MEMORANDUM

DATE: January 27, 2026

SUBJECT: Iron Mountain: Amendment of Approved Preliminary Subdivision Plat/
Special Exception Use Permit for a Residential Planned Development
Project (PDP)
PID: 272922866300041010
PUBLIC HEARING – Requirements have been met.

Amended Plan B

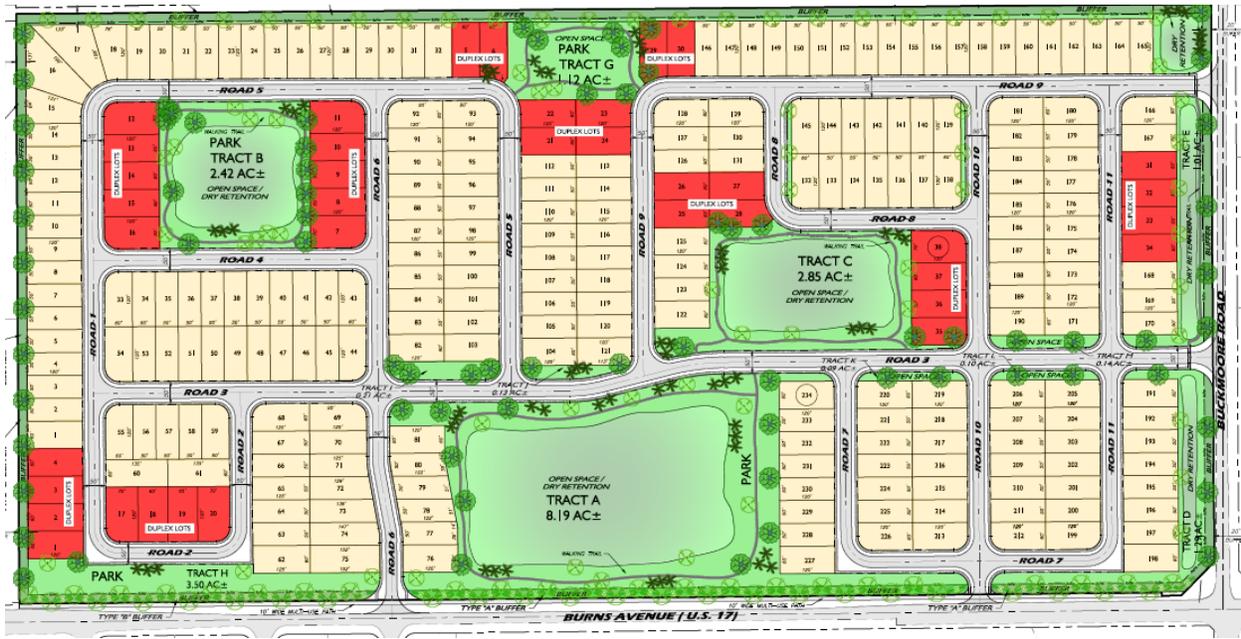
Waivers of Strict Compliance: Plan B

- 1.) Reduction in required side yard setback to 5 feet where 10 feet is required by code (single-family detached).
- 2.) Reduction in required interior side yard setback to 0 feet where 10 feet is required by code for attached duplex units only.
- 3.) Reduction in required rear yard setback to 15 feet where 20 feet is required by code.
- 4.) Reduction in the minimum road frontage for lots to 50 feet in width for single-family detached and to 30 feet in width for each duplex lot, where 75 feet is required by code.
- 5.) Increase in the maximum lot coverage for the duplex lots to 70% where 60% is required by code.

6.) Waiver from required alleyways for lots smaller than 50 feet in width (duplex lots).

The development provides two access points off of Burns Avenue, and two access points from Mammoth Grove Road, both County Roads. The latest plan amendment includes reconfiguration of the lots which were previously designed with the backs of homes along Burns Avenue, a development pattern the City has sought to avoid in recent years.

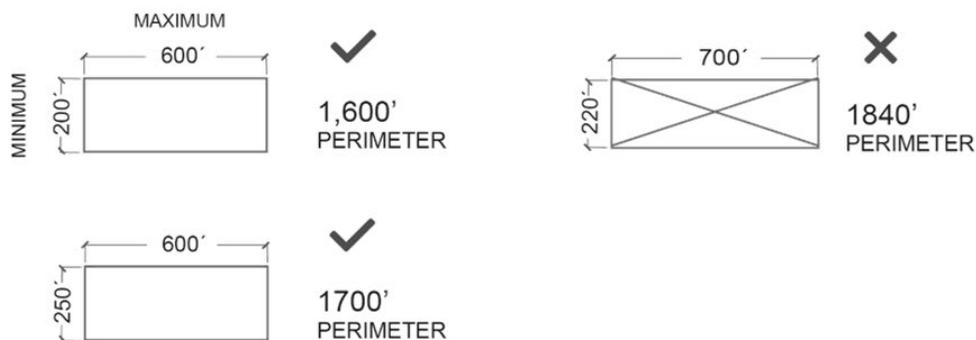
Overall design. The layout of the development is suited to the configuration and characteristics of the land and integrates natural features into the overall design, including wetlands, ponds, hills, and vegetation.

Staff comment: The site is high and dry, and vegetated with failing citrus.

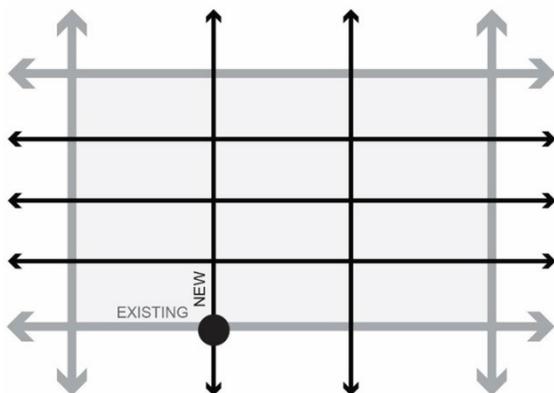
New streets shall connect to existing streets to create new street grids and patterns. The street layout of a new neighborhood shall provide for the continuation of streets already existing in adjacent areas. Stub-outs to adjacent undeveloped parcels shall be provided with a spacing no greater than 1,000 feet.

Staff comment: Street interconnectivity is achieved to the greatest extent feasible.

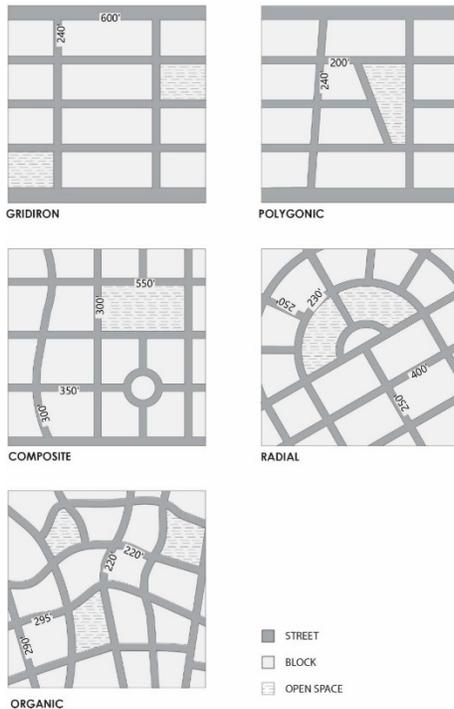
Street grids can include a variety of patterns, as shown in the graphics below, with blocks of equal or varying sizes provided they meet the block length requirements outlined in section 23-443.1, new development block standards.

Staff comment: Street pattern is gridiron.

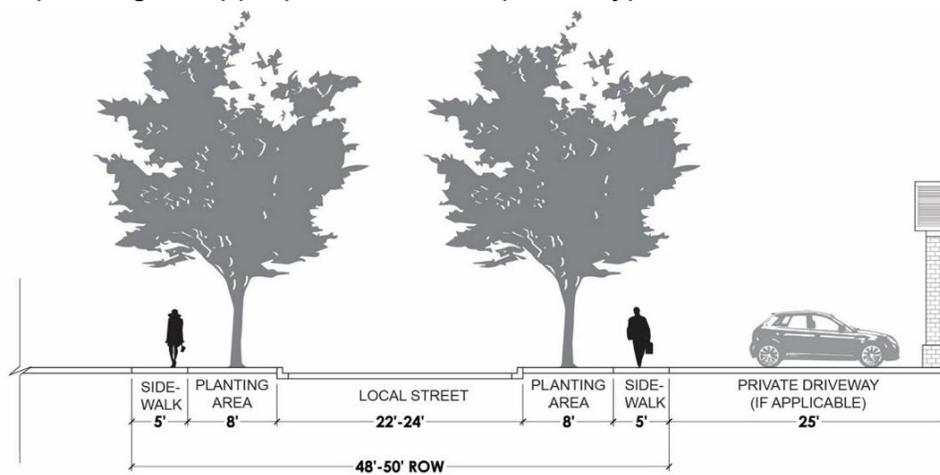
Sidewalks shall be provided on both sides of all streets.

Staff comment: Sidewalks are proposed on both sides of the streets.

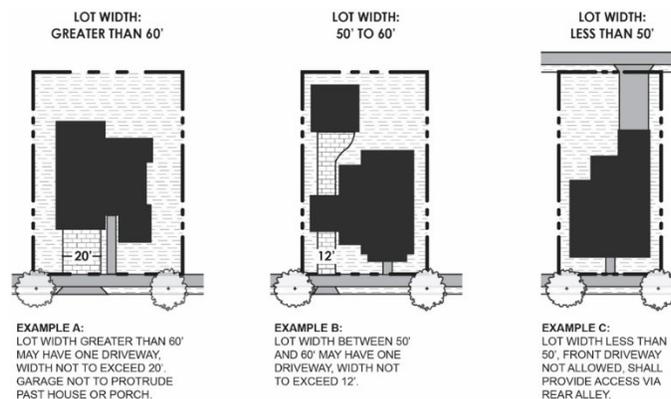
The minimum length of a driveway shall be 25 feet measured from the property line.

Staff comment: Driveways shall meet this standard.

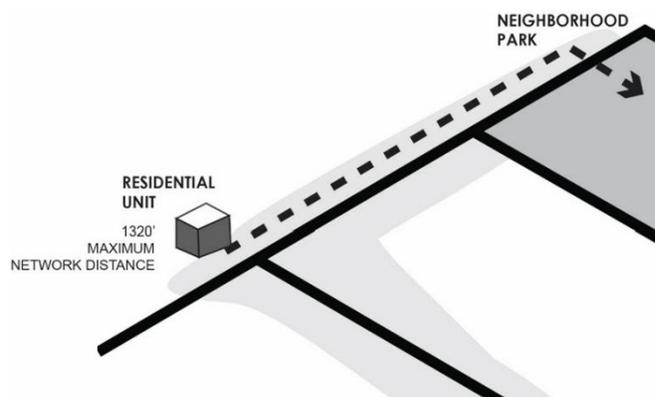
All residential lots shall be within 1,320 feet of a neighborhood park, based on walkable street/network distance.

Staff comment: Qualifying parks meet the distance requirement.
